NUMBER: 23-005-21 REV. B

Front Seat Side Shield Updated Service Procedure

2014 - 2019 (KL) Jeep Cherokee

Fig. 1
Back Side Shield Hole Being Elongated

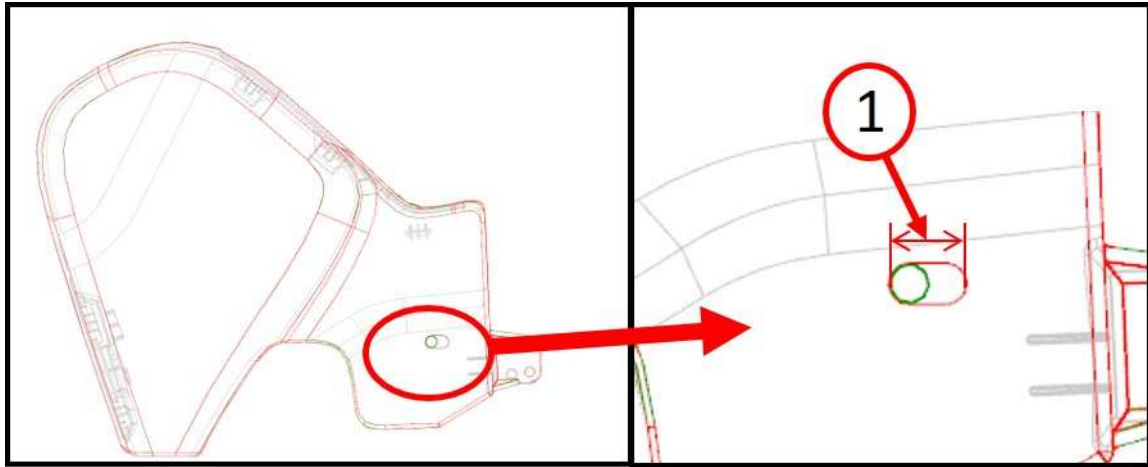
2. Remove inboard side shield. Refer to the detailed service procedures available in DealerCONNECT/Service Library under: Service Info 23 - Body / Seats, Front / Side Shields, Seat, Manual (or Power) / Removal.
3. Use a hand held rotary multi use tool or a file (Fig. 1) to elongate the hole to 12.5 mm (.5 in.) slot (Fig. 2) .

NOTE: When the buckle is replaced, ensure that the buckle is tightened to the seat at 45 N·m (33 ft lbs.).
